A	06/05/26	MH	Amendments as per planning officer (C Lamb) comments in email dated 30/04/26
---	----------	----	--

client	Mr R Abdul		
project	35 Brookdene Drive, Northwood HA6 3NS		
drawing	STEP FREE ACCESS & DOCUMENT M4(2) COMPLIANT		
date	scale	project no	
Oct. 2025	1:100 at A3	2025.034	
work stage	drawing no	revision	
3	C01	A

client	Mr R Abdul		
	project	35 Brookdene Drive, Northwood HA6 3NS		
	drawing	STEP FREE ACCESS ELEVATION		
	date	Nov. 2025	scale	1:100 at A3
	work stage	3	drawing no	C02
			project no	2025.034
			revision	A
www.masonwoodgroup.co.uk gc@masonwoodgroup.co.uk 020 7118 5040

NORTH - EAST
Front

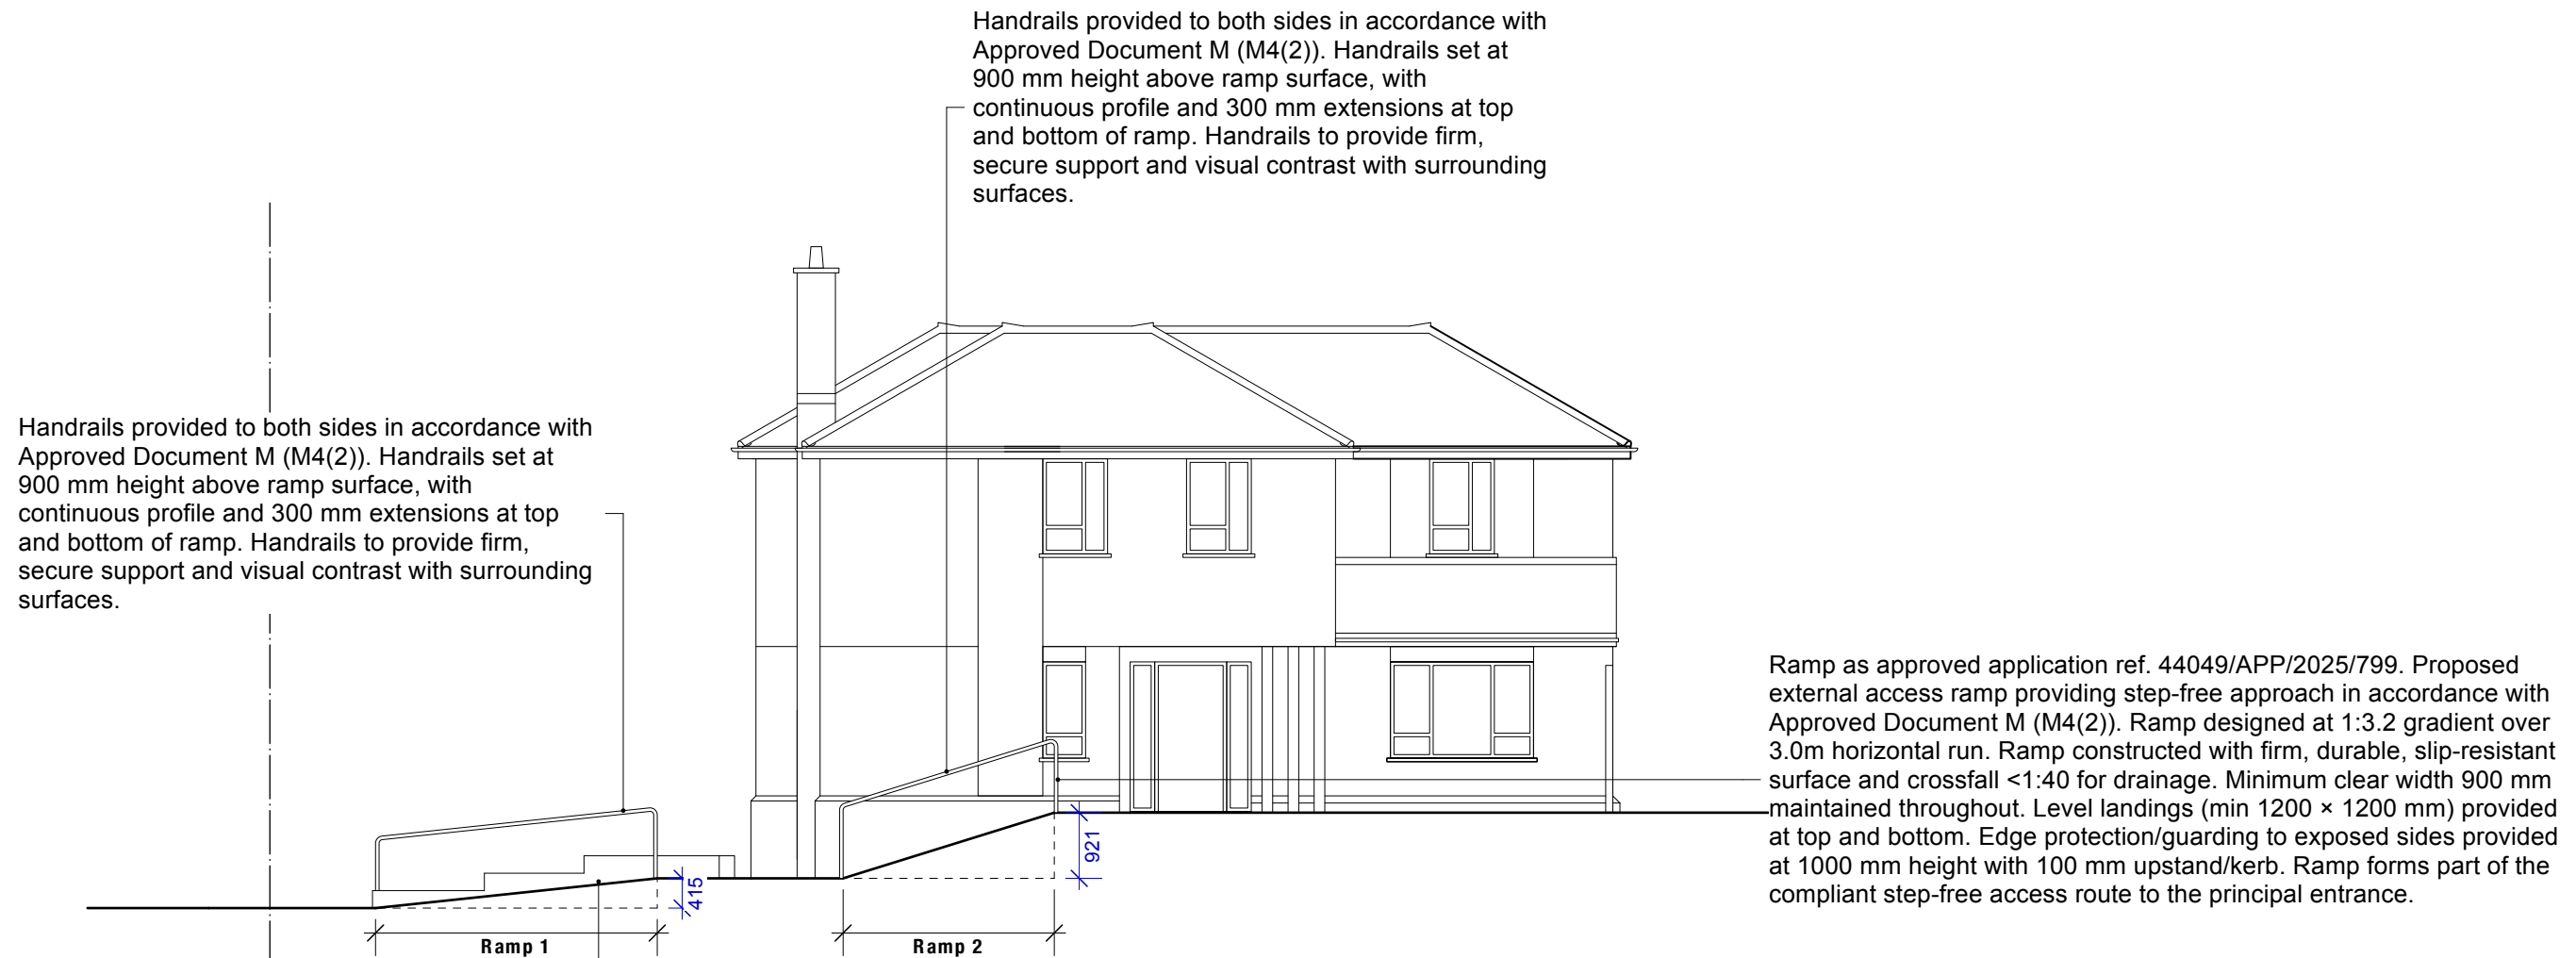
A	06/05/26	MH	Amendments as per planning officer (C Lamb) comments in email dated 30/04/26
Revision notes

Handrails provided to both sides in accordance with Approved Document M (M4(2)). Handrails set at 900 mm height above ramp surface, with continuous profile and 300 mm extensions at top and bottom of ramp. Handrails to provide firm, secure support and visual contrast with surrounding surfaces.

Ramp as approved application ref. 44049/APP/2025/799. Proposed external access ramp providing step-free approach in accordance with Approved Document M (M4(2)). Ramp designed at 1:3.2 gradient over 3.0m horizontal run. Ramp constructed with firm, durable, slip-resistant surface and crossfall <1:40 for drainage. Minimum clear width 900 mm maintained throughout. Level landings (min 1200 x 1200 mm) provided at top and bottom. Edge protection/guarding to exposed sides provided at 1000 mm height with 100 mm upstand/kerb. Ramp forms part of the compliant step-free access route to the principal entrance.

Ramp as approved application ref. 44049/APP/2025/799. Proposed external access ramp providing step-free approach in accordance with Approved Document M (M4(2)). Ramp designed at 1:9.5 gradient over 5.0 m horizontal run. Ramp constructed with firm, durable, slip-resistant surface and crossfall <1:40 for drainage. Minimum clear width 900 mm maintained throughout. Level landings (min 1200 x 1200 mm) provided at top and bottom. Edge protection/guarding to exposed sides provided at 1000 mm height with 100 mm upstand/kerb. Ramp forms part of the compliant step-free access route to the principal entrance.
